## HPC-22-17 Steel Facade

November 16, 2022

**To:** Historic Preservation Commission  
**From:** Wade Broadhead, Senior Planner  
**Through:** Scott Hobson, Acting Director of Planning and Community Development  
**Location:** 322, 324, and 326 S. Union Ave  
**Applicant:** Fred Gonzales  
**Owner:** Henry Borunda  
**Year Built:** Remodeled 1945  
**Legal Description:** Lot 4, Block 58, South Pueblo  
**Zone District:** HB, Historic Business Zone District

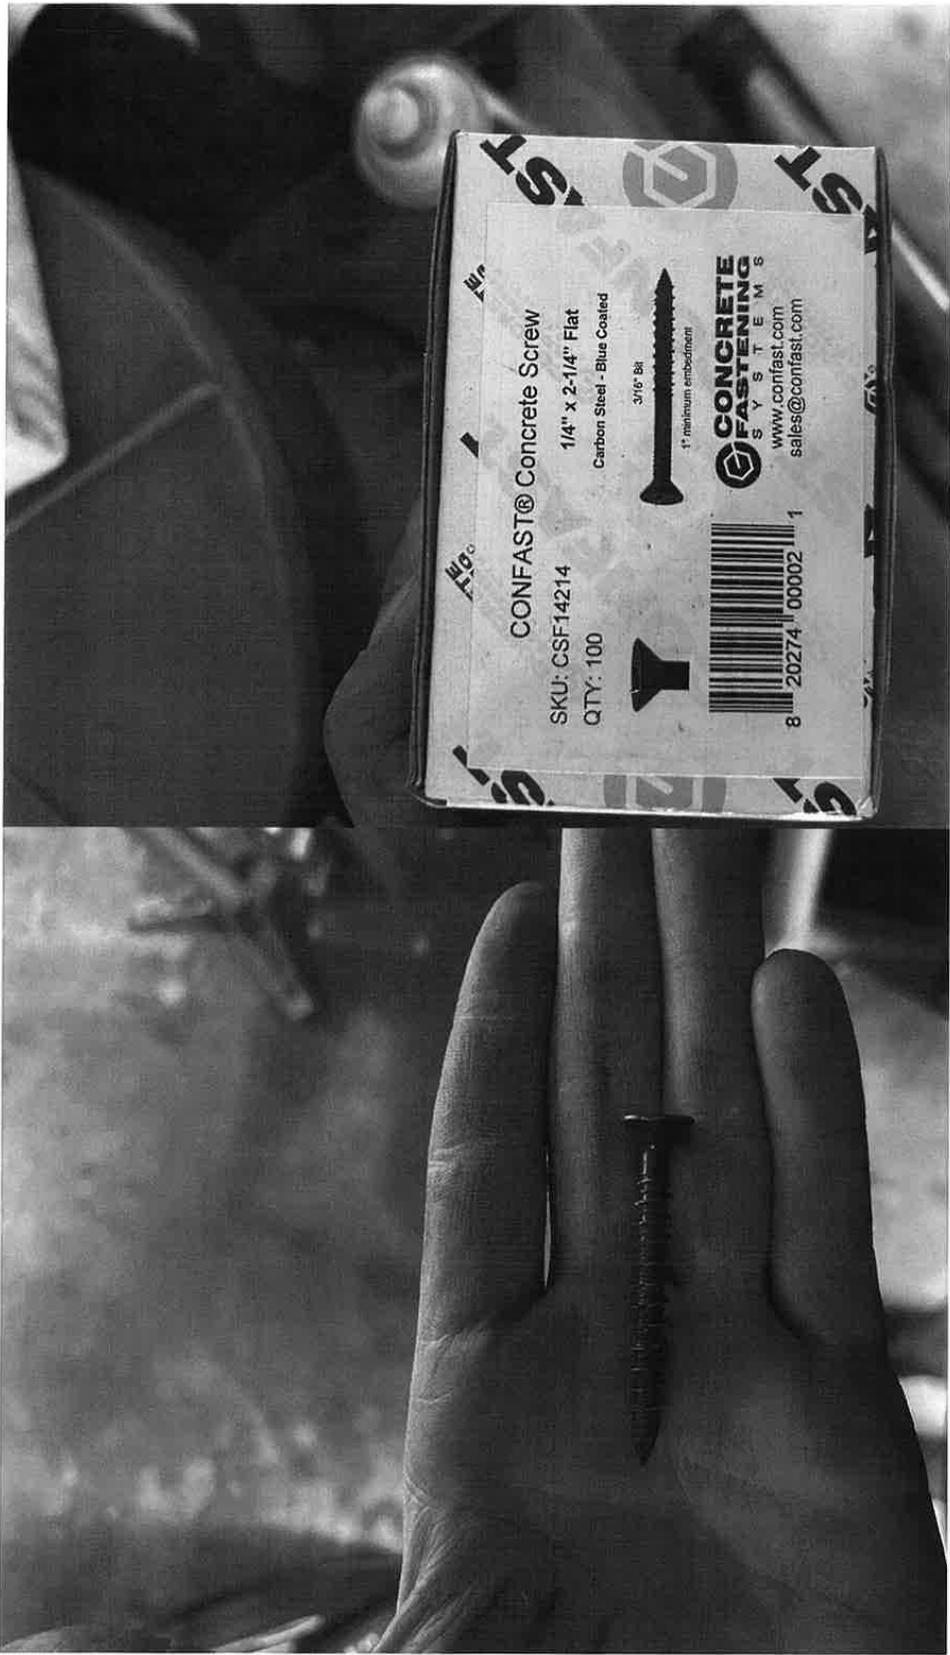
*Finding:* The steel panels are welded to each other, glued and screwed to the yellow glazed brick façade. Because construction adhesive and screws were used to apply the steel the steel is not considered independent and removal will damage the yellow brick façade. .

*Finding:* The application of the steel façade, the adhesive, and a number of screws will damage the underlying brick and block when removed.

The proposed steel façade does not conform to the Pueblo Historic Business District Guidelines or Standards of Appropriateness; therefore, a COA cannot be issued, and modifications shall be removed. The owner may submit a revised application with modifications to the steel façade to meet the criteria of the HB Guidelines and Standards of Appropriateness.
